PLANNING BOARD AGENDA
FEBRUARY 8, 2024 – 7:00 P.M.

Re: Veolia (formerly Suez) Water
Mahopac Wells
Tax Lot 75.20-2-68

The following is our response to Richard J. Franzetti, P.E, letter dated March 8, 2022:

TITLE: GRADING PLAN

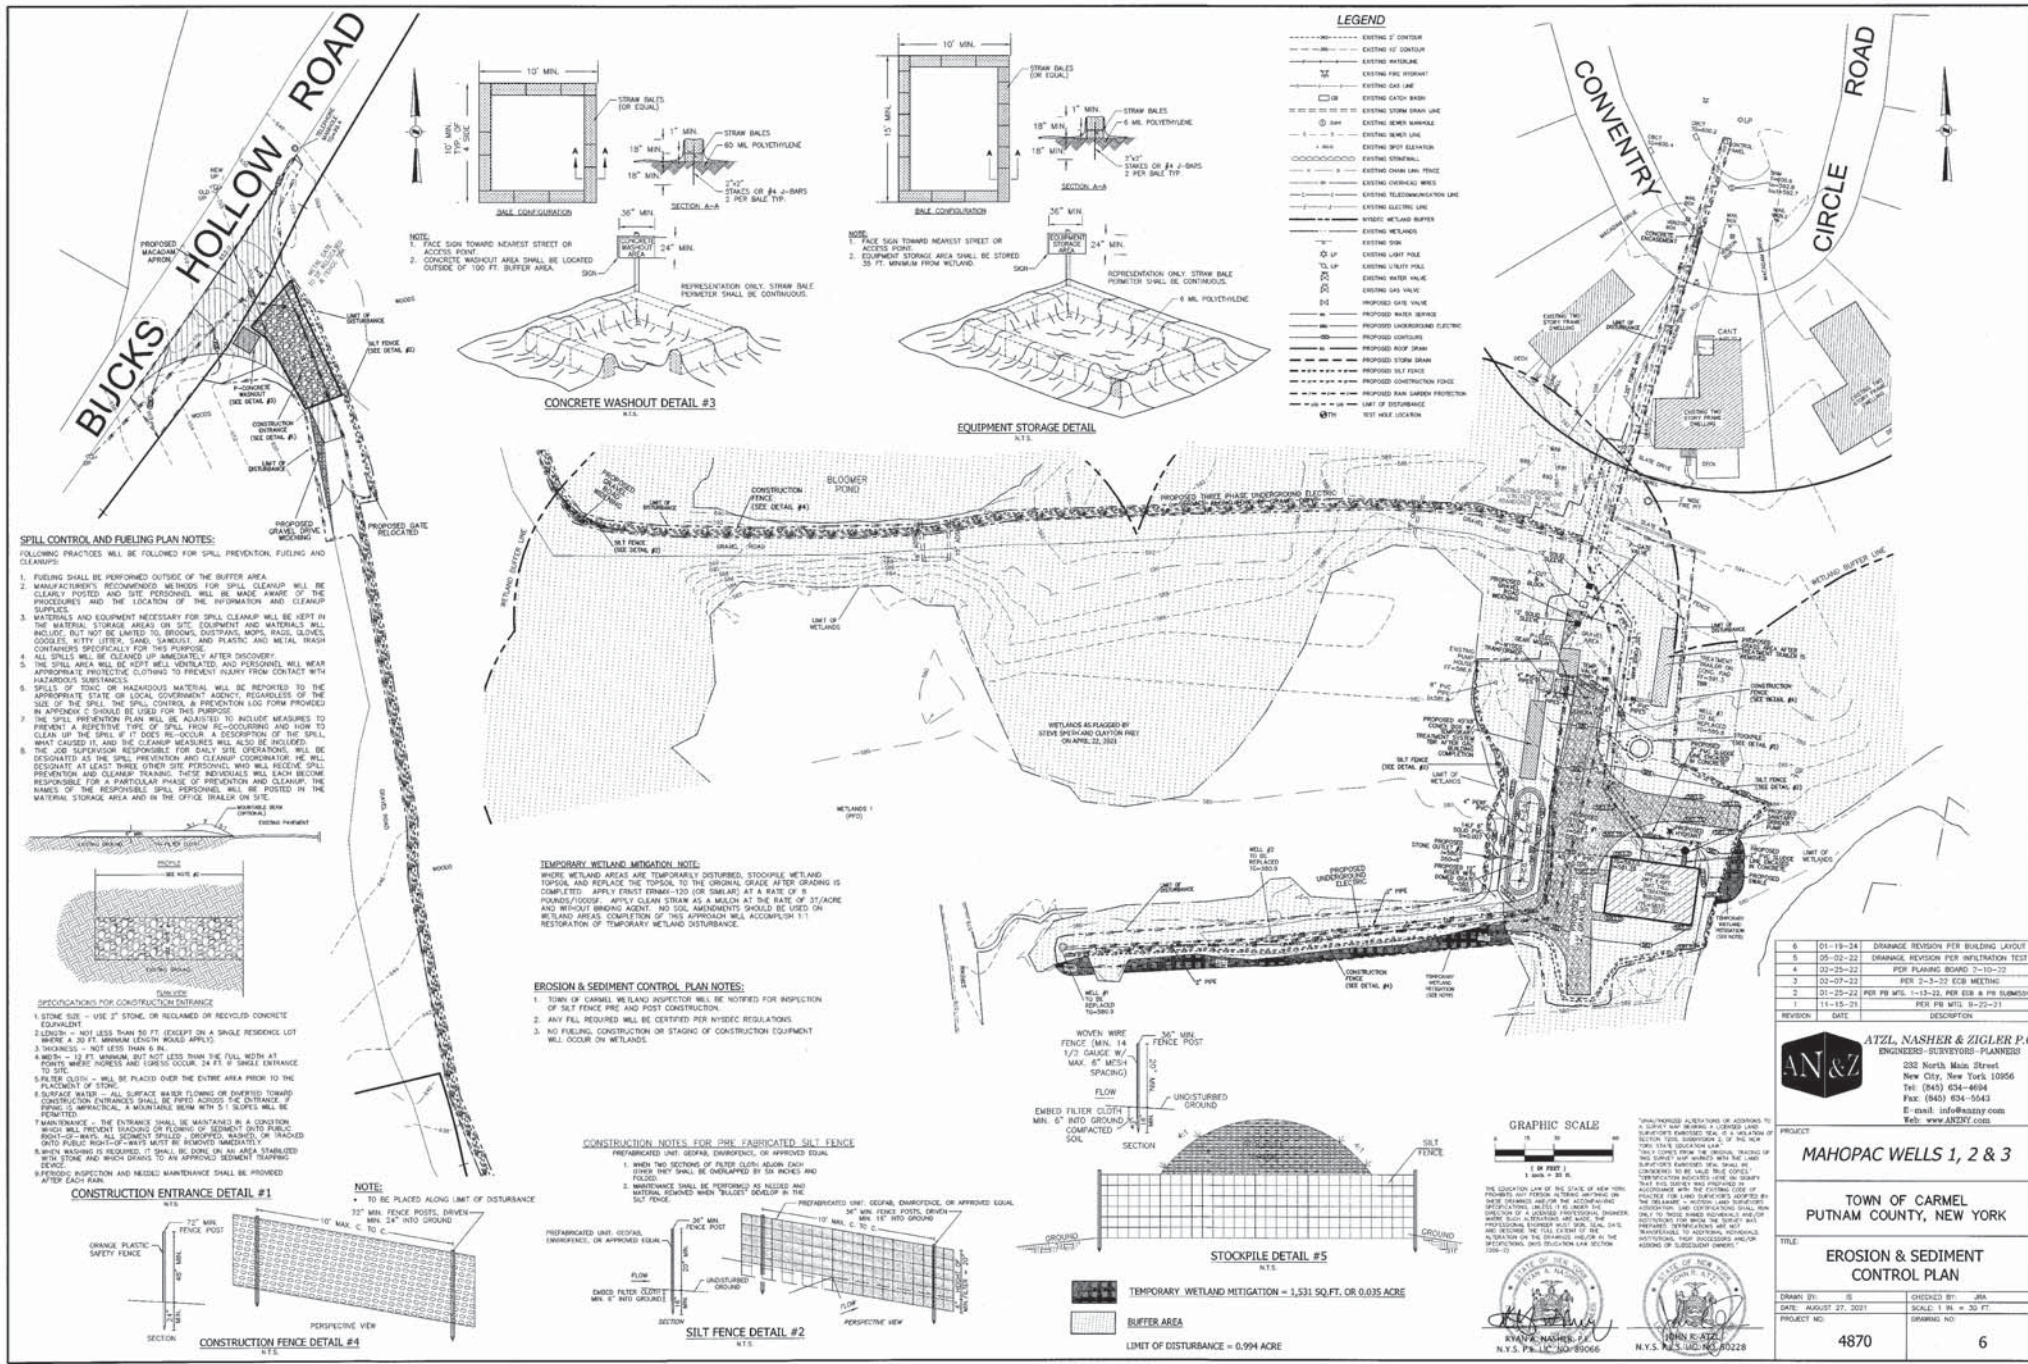
3. Comment: The area of disturbance for the work as provided is now 2.07 acres. The threshold criteria of disturbances for the NYSDEC stormwater regulation are between 5,000 square feet and one (1) acre and over one (1) acre. The project will require coverage under the NYSEC SPDES General Permit for Stormwater Discharges from Construction Activity (GP-0-20-001) and the development of Stormwater Pollution Prevention Plan (SWPPP) that has permanent stormwater controls.

Response: The area of disturbance has been revised to 0.994 acres. This has been noted on sheet 4 – grading plan. An updated SWPPP is being provided with this submission for review by the Town Engineer. Cut fill analysis along with a note regarding fill has also been provided on sheet 4.
